# 1 CAP1616 Stage 2 Engagement Record: LCY-Airline Technical Meeting 7th Dec 2021

# 1 CAP1616 Stage 2 Engagement Record: LCY-Airline Technical Meeting 11<sup>th</sup> January 2022

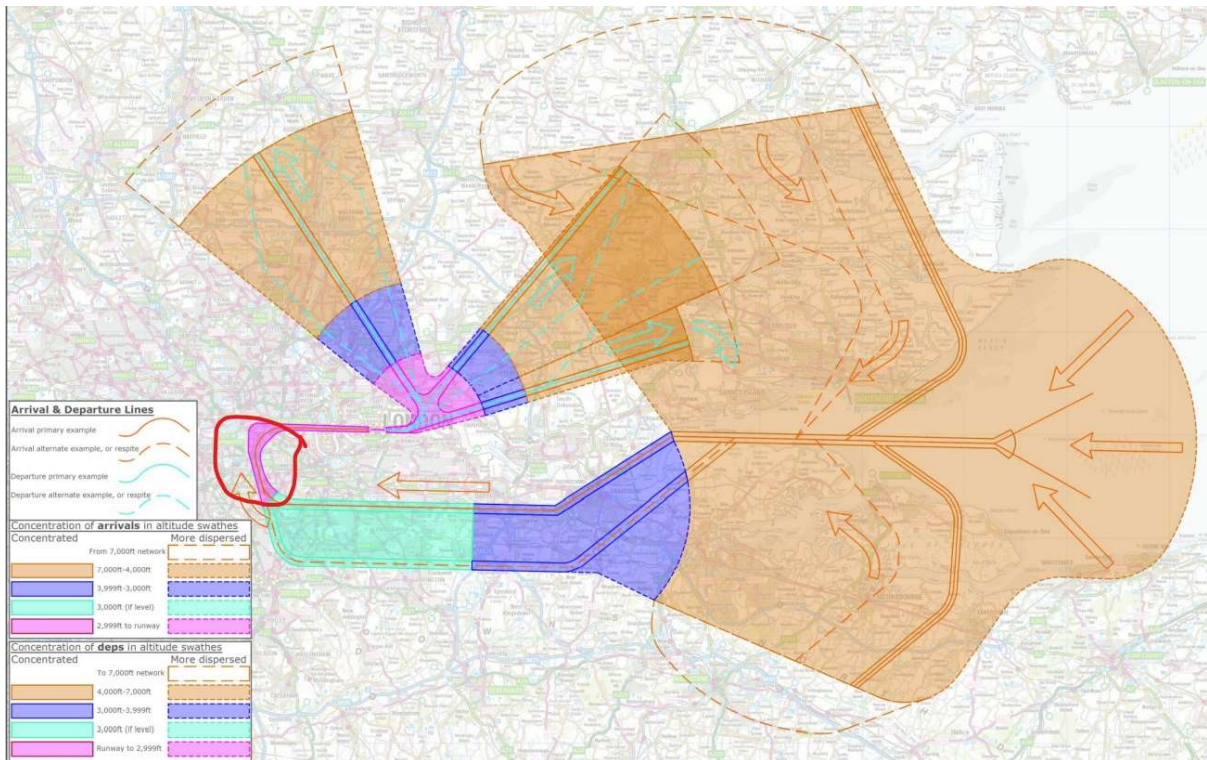
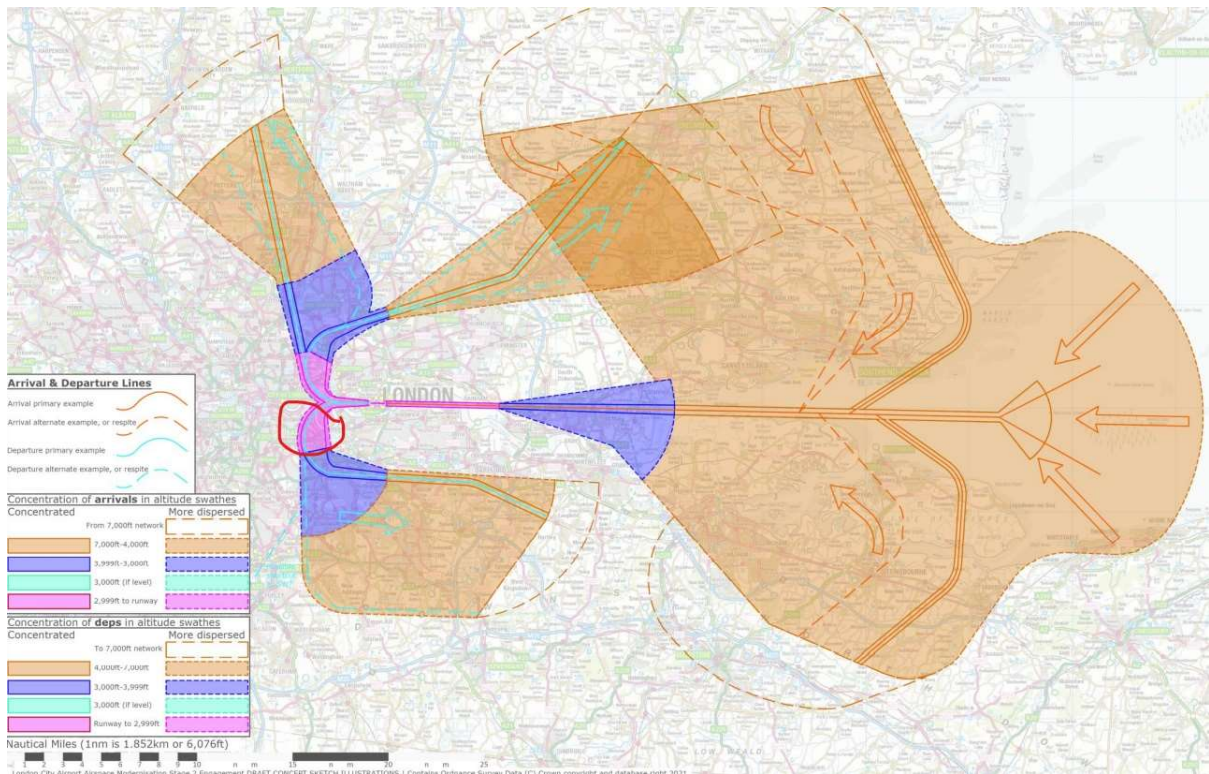
**1 The easterly proposal 1 for arrivals** shows absolutely no assistance to the red-ringed area. Concentration is still inflicted in the pink approach and noise is made multi-fold by the fact that planes are banking to turn onto the final approach. All proposals have the same problem for the area in pink. Supporter comment 'My life was a misery under this'. It was introduced in 2016.

**2 The westerly proposal 1 for departures terrifyingly** shows a new departures option that could well start to bring planes over the same area inflicted in the easterly proposal: The pink area departing to the south. This would be a new horror for people already inflicted by easterly arrivals to LCY simultaneously with westerly arrivals to LHR. Culminating in absolutely no rest from planes overhead at 2000-3000 feet.

Whatever height increase is proposed or occurs looks unlikely to be present at the red-ringed pink routes. Dependent on LHR routes being high enough, which also seems unlikely to be enough of a change to make a difference for population in the red-ringed areas. These people are 'just to suffer' starting from 2016 without any respite.

Fig 1. Possible easterly arrivals routes over SE London. Source LCACC meeting Dec 2021.

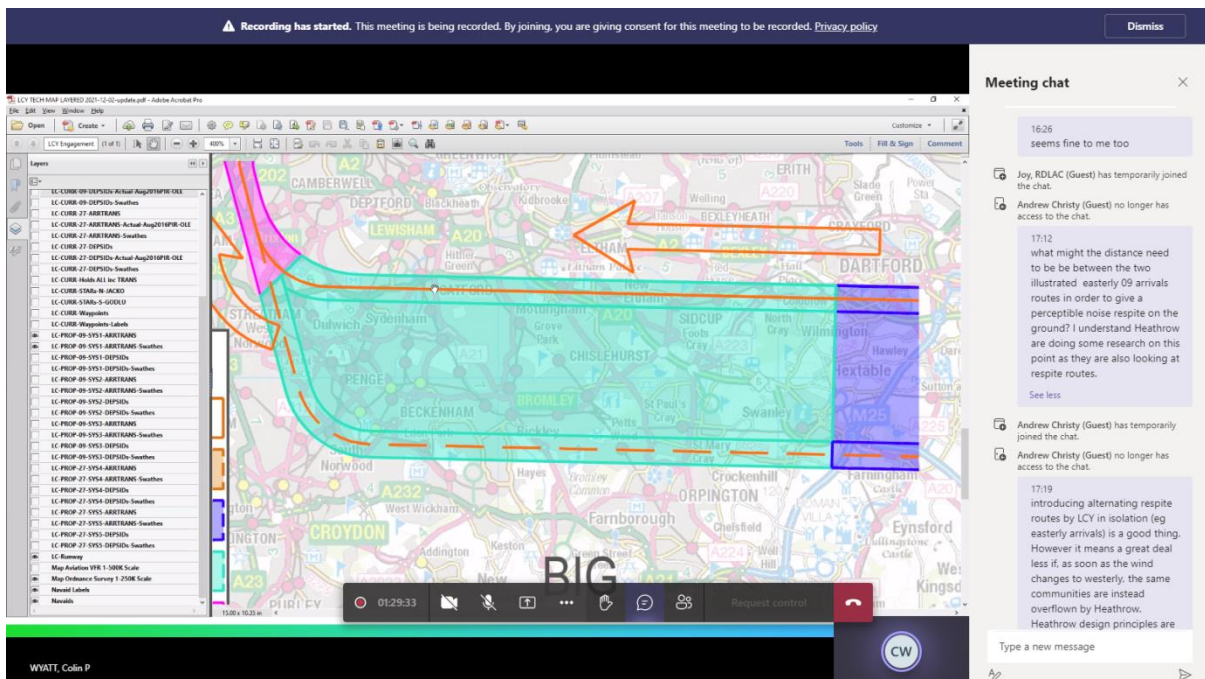
Over Lewisham this two route suggestion (Fig 1) would be an improvement, and is probably something that should have been designed in 2016 in response to public and Local Authority representations.

While we understand that this is indicative only, the distance between the two respite routes could be wider than shown. The airport decided in 2015 to take a central concentrated route down a previous widely dispersed route. It would appear that aircraft can be flown both further north and further south of the current route shown in solid line. The northerly route shown flies directly over Catford, while planes prior to 2016 (see below) are shown some 2 km further north as well as quite further south.

Fig 2. London City arrivals path prior to 2016. Source. London City Airport

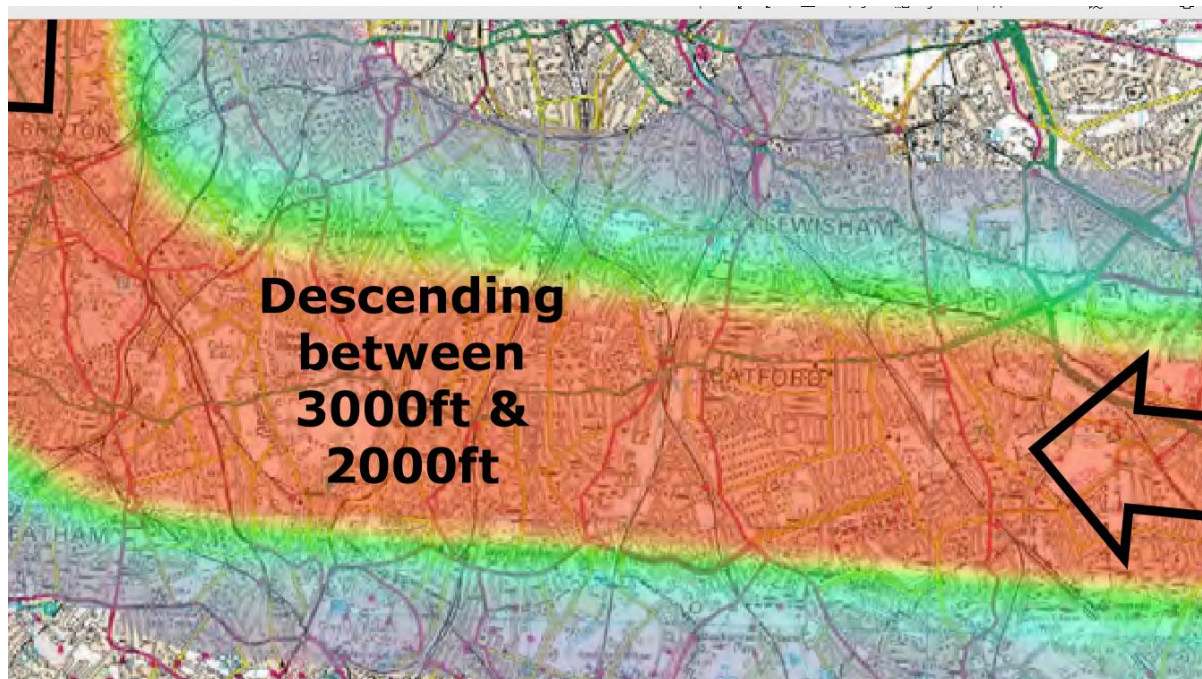
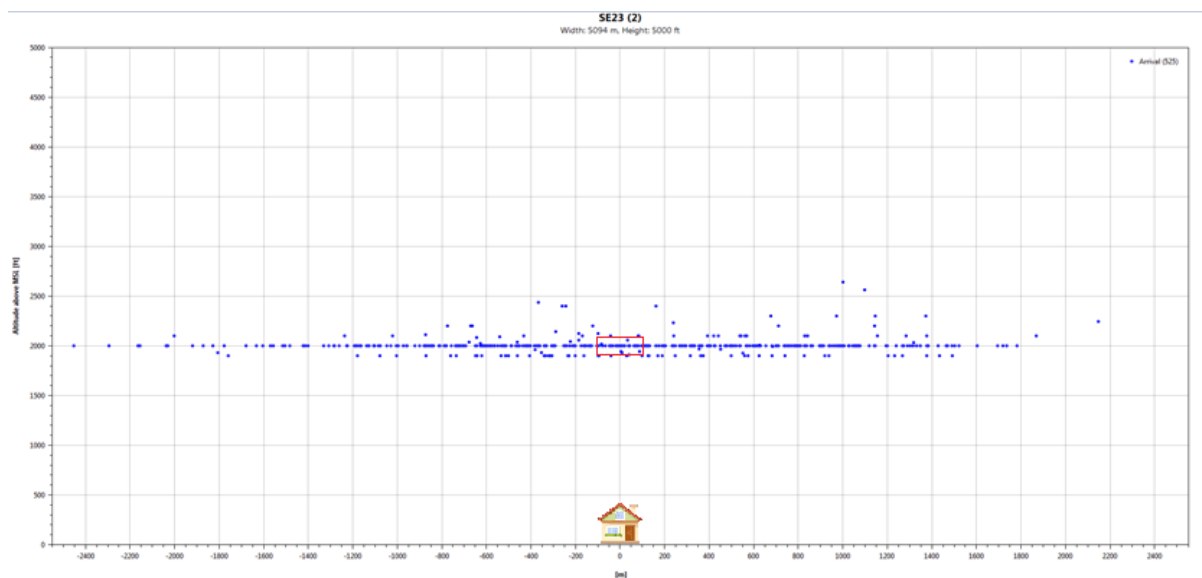
It would also appear from pre 2016 flight path data (Figs 2 and 3) that London City aircraft can be flown in both a tighter curve, keeping further east or west in a wider curve. This might give options for respite routes to continue wider further north than shown in pink in System 1 (Fig1) over, say, Dulwich to Vauxhall.

**Fig 4. Heathrow arrivals crossing points over London City flight path in SE London – even 32km to landing, City fly low, just over 2000ft**

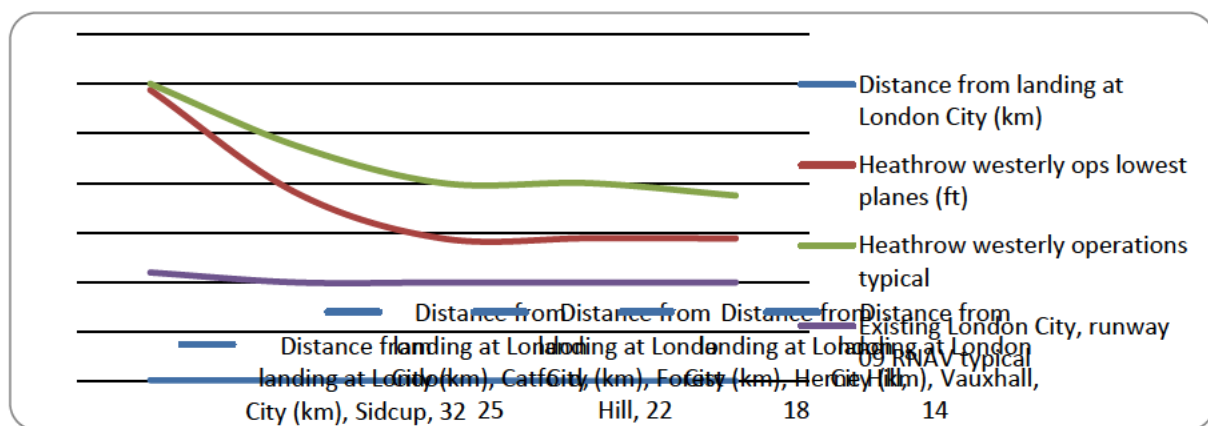
Below (Fig4) we show that still 32 km from landing, near Sidcup, aircraft are low and already only around 2000 feet above Mean Sea Level. The red and green lines show the typical heights of Heathrow aircraft as they cross over the concentrated London City flightpath at 6000 feet near Sidcup (32 km from landing), as low as 3000 feet from Forest Hill to Vauxhall.

As long as Heathrow and London City change runway direction independently of each other, then these paths operate simultaneously on some days. So, for London City to fly a much higher CDA similar to the one they fly over the Thames estuary on westerly (27) approaches, Heathrow must create paths avoiding the space above the City flight path

**Fig 5. London City (runway 27) arrivals descend steeper, and fly much higher for far longer when landing from the east**

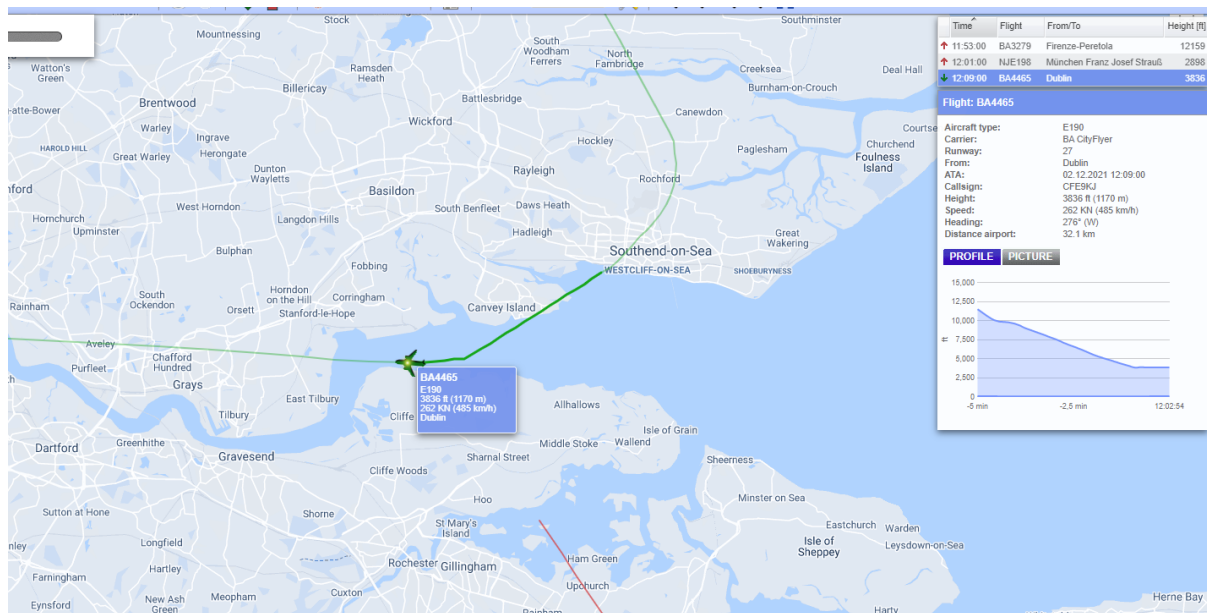
Below (Fig 5) we see the much steeper and CDA London City profile over the Thames Estuary arriving from the east. 32 km from landing the aircraft is still at nearly 4000 ft, and does not reach 2000ft until about 8 km from landing.

We repeat, by comparison at 32 km from landing on easterly (09) approaches City aircraft are only just over 2000ft, creating a low and concentrated noise nuisance over a vast area of densely populated SE London. Even with addition of respite routes this kind of descent profile cannot be seen as acceptable in a major world city.

**Fig 6. Heathrow westerly arrivals fly broad curves over SE London. Source Heathrow airport.**

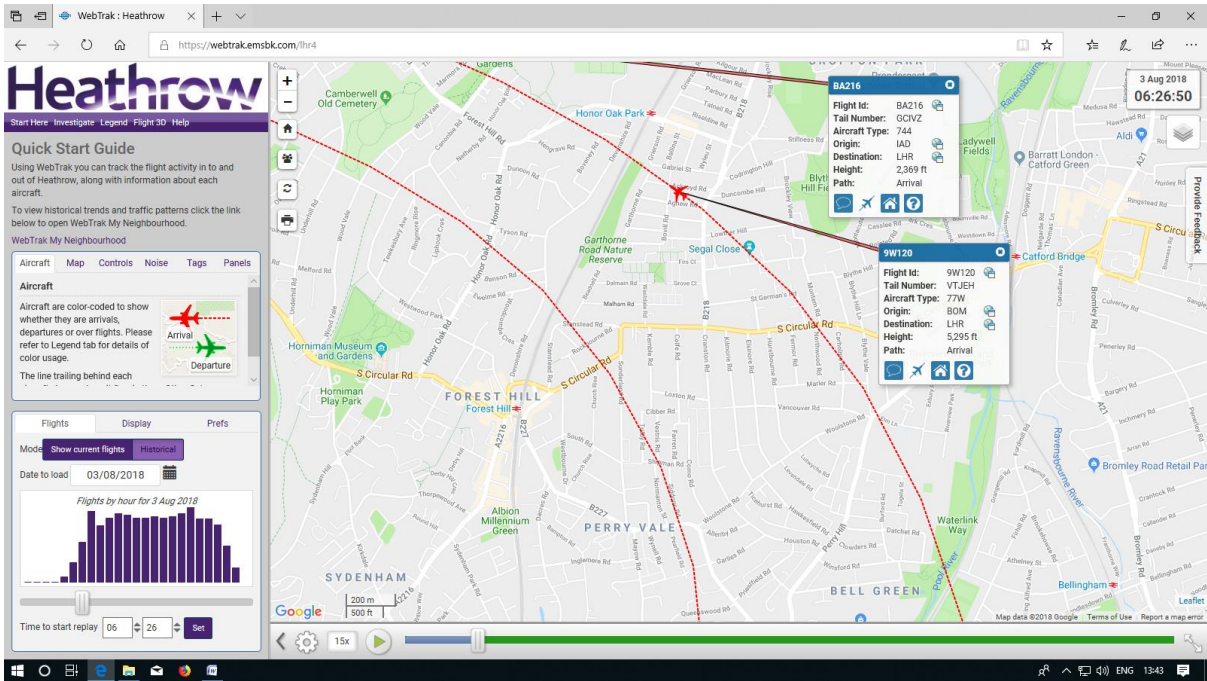
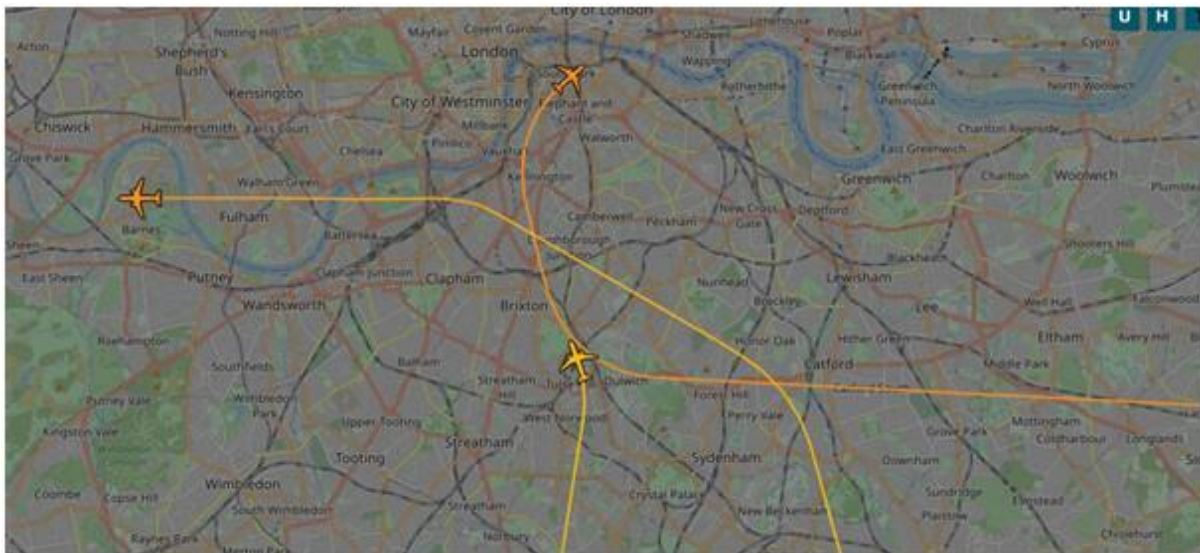
Below (Figs 6 and 7) we illustrate the problem in SE London. Heathrow westerly arrivals fly in a wide series of curves over Lewisham from the south, while London City easterly concentrated arrivals curve over from the east. On light easterly conditions both occur at the same time. Barring very occasional east wind Saturday afternoons and Sunday mornings when City does not fly, this means there is no noise respite for these communities when combining the impacts of the two airports.

Rather than expect Heathrow to 'lift their lid' enough to make a difference in this area, which seems unrealistic, the two airports need to share airspace in such a way that CDA approaches and equivalent ascents, together with alternative respite routes can be flown by London City. For example, Heathrow arrivals could remain geographically West of the Brixton area, while City remains east, eliminating the crossing of flight paths and allowing a Continuous Descent Approach.
